Village of Barrington Hills

Longmeadow Parkway Neighborhood Meeting

October 8, 2014

Preliminary Plan Submittal

– Autumn Trail Pavement Section Comparison

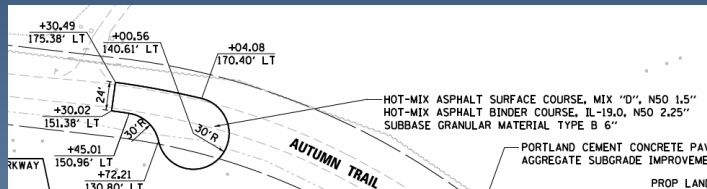
- Recommendation: Request 2" minimum surface thickness and 10" aggregate base course.

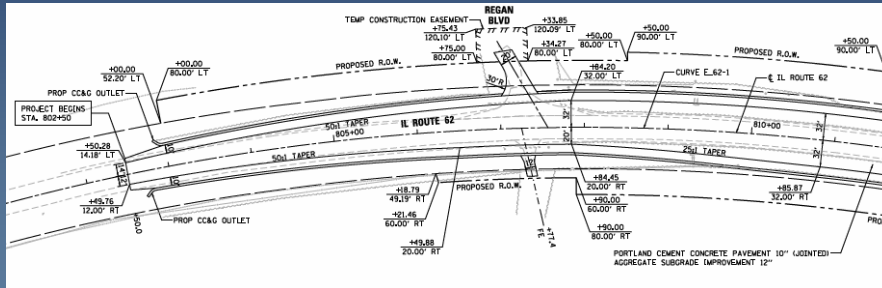
- Proposed Retaining Wall #1 blocking secondary access to 149 Algonquin Road

- M4.24 Concrete Curb & Gutter
